Permit No.: C-1992-081

Brief Description of Revision: Change in Postmining Land Use (PR20-02)

EXHIBIT 20-1 POST-MINING LAND USE	
DESIGNED BY: MLK DRAWN BY: MLK APPROVED BY:	COUNTRY: USA STATE/PROVINCE: COLORADO GSC: 6N 88W
DATE: 2021-11-10 SCALE:	DRAWING/SHEET: 1 of 1 C.I.: 0'

RE: Hayden Gulch Terminal, LLC - Hayden Gulch Loadout (C-1992-081), Permit Revision (PR20-02) for a Change in the Postmining Land Use, Adequacy #1

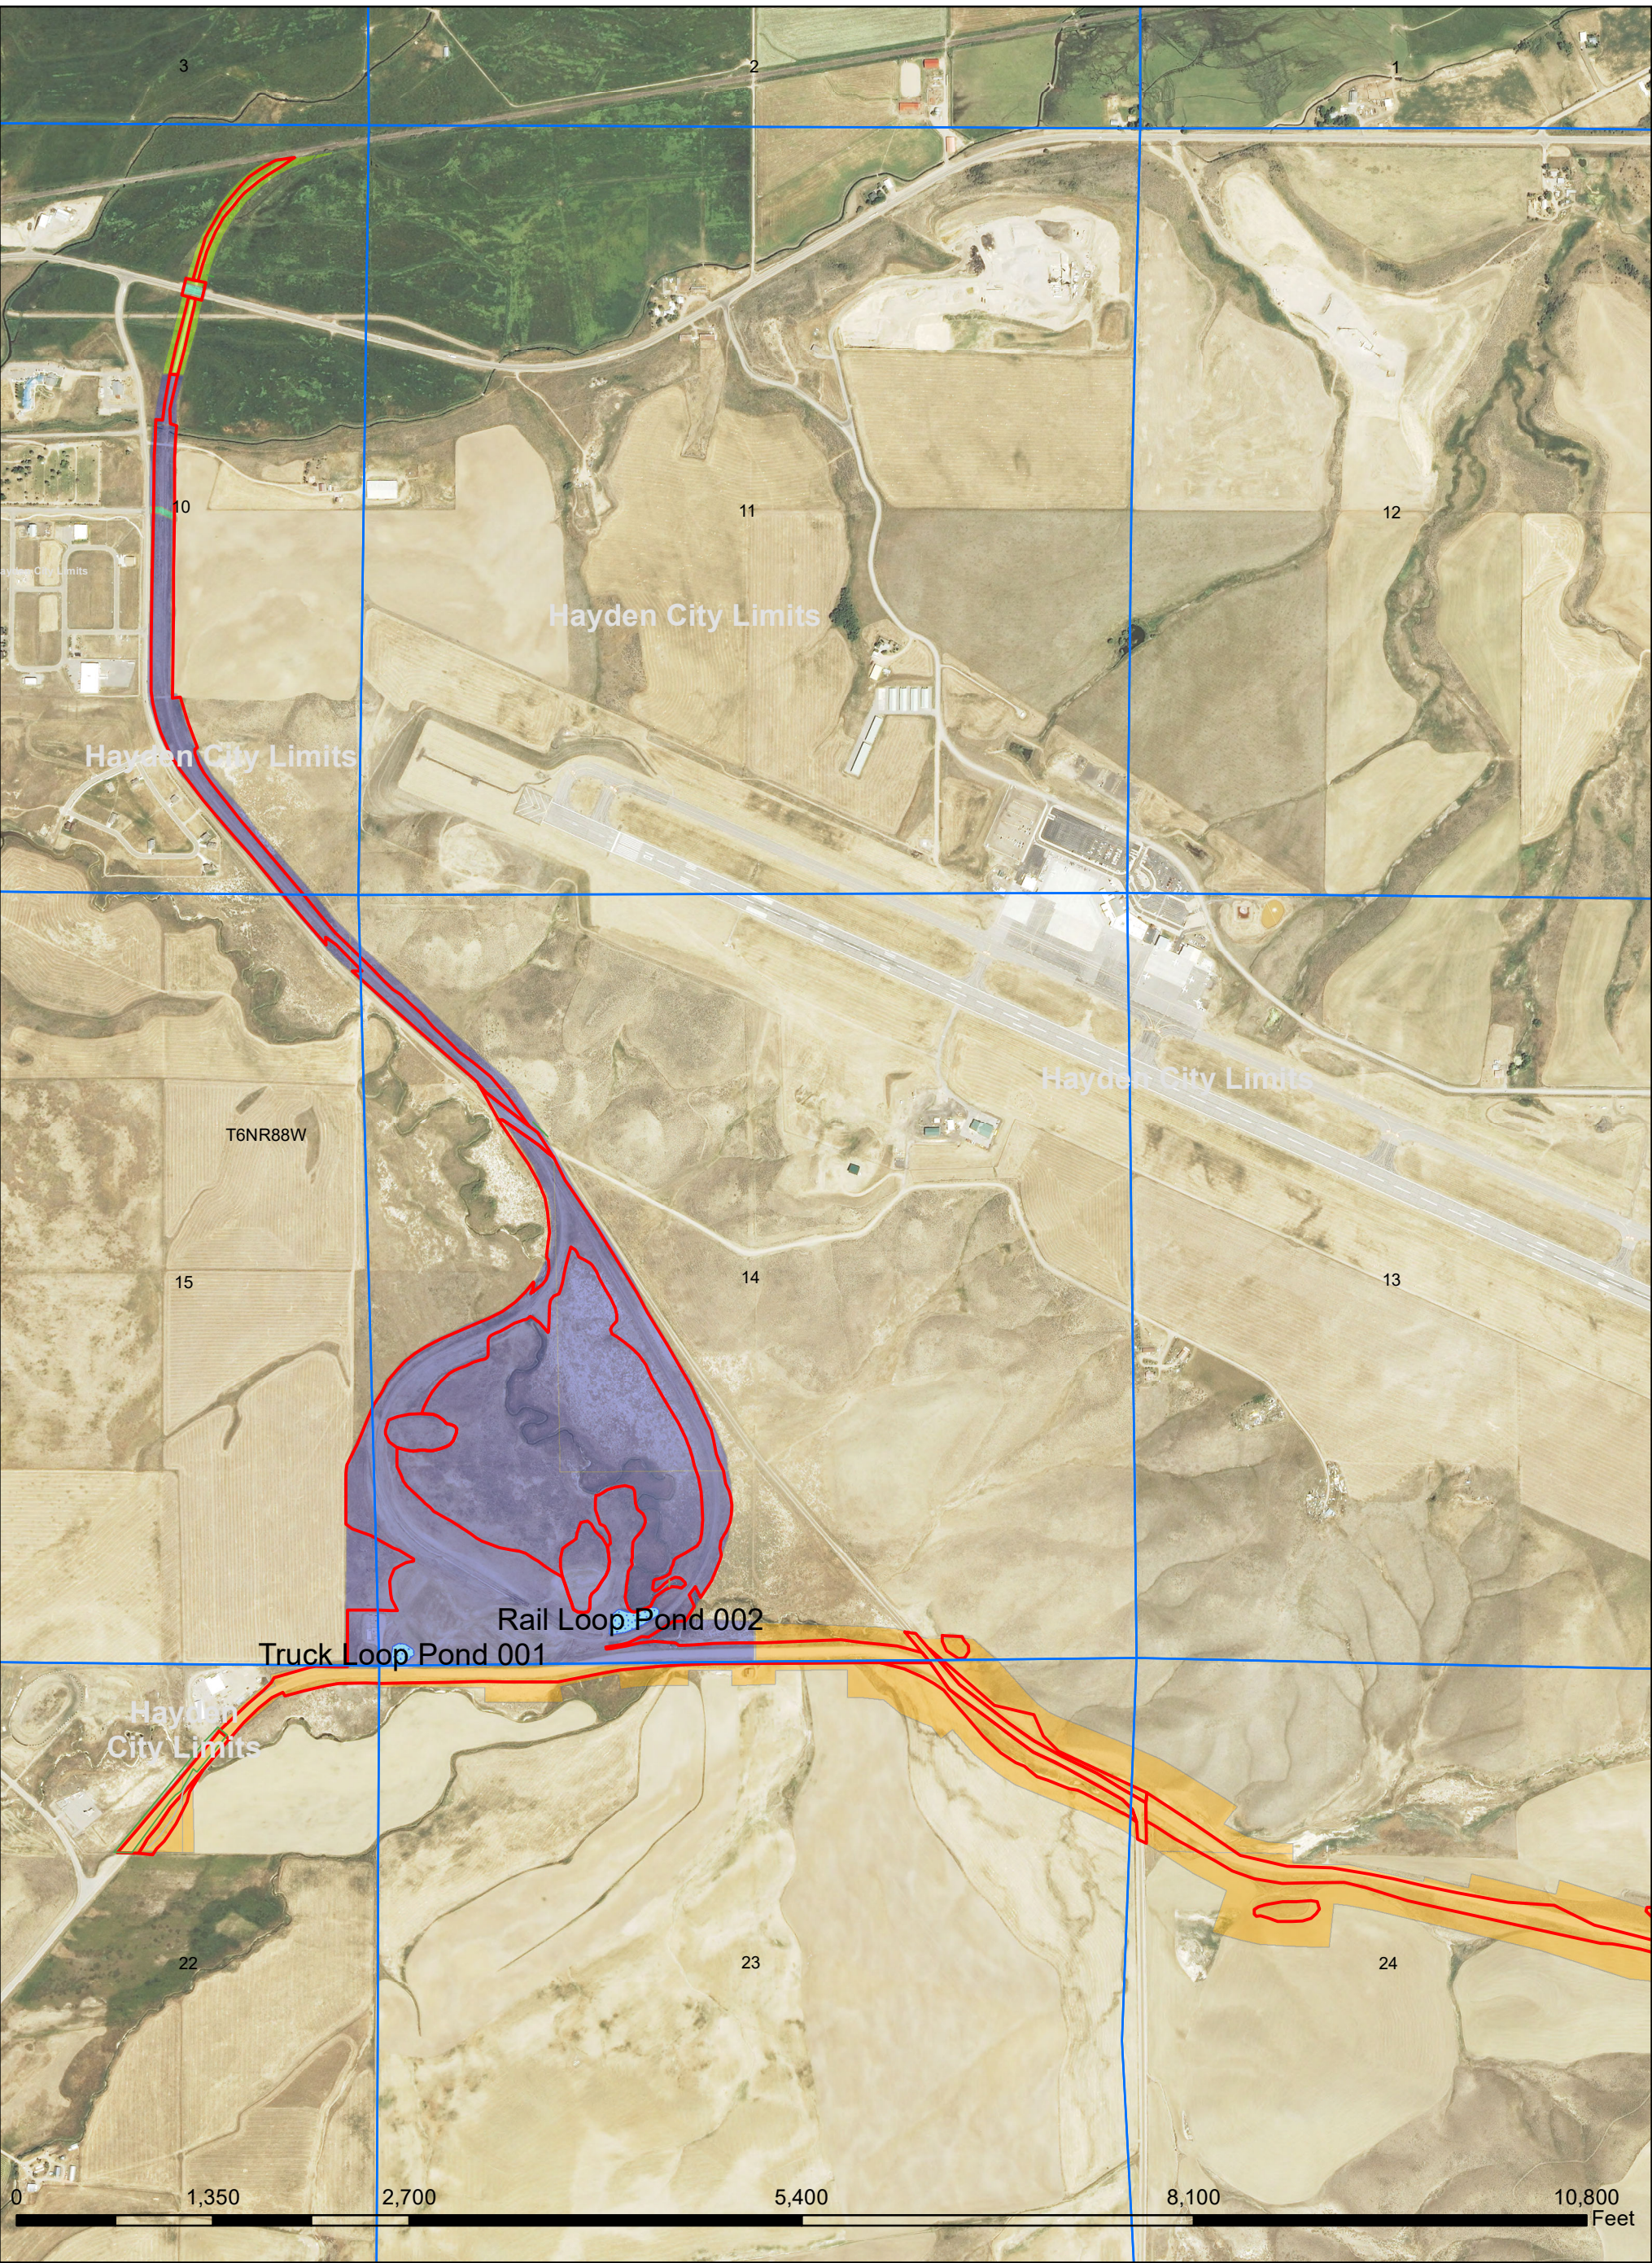
- 3.2 Please update Exhibit 20-1, the Post Mining Land Use Map to clearly show these acres, including labeling the number of acres in each category, including the permit boundary, and including all corner latitude and longitudes so that the Division can verify acres.

- b. HGL has updated Exhibit 20-1, Post Mining Land Use Map and has attached it with this submittal.
 - 3.3 Please update the map key on Exhibit 20-1 to include all colors shown on the map.

- 3.4 Please identify the ponds proposed to be left in place and the monitoring well on the post mining land use map Exhibit 20-1, if these are intended to become permanent features.

- a. HGL has updated Exhibit 20-1, Post Mining Land Use Map and has attached it with this submittal.

- b. The Truck Loop Pond and the Rail Loop pond will remain in place post mining. These ponds have been identified on Exhibit 20-1. Shallow Well HGDAL3 will be pulled and abandoned by HGL prior to turning the property over to the Town of Hayden.
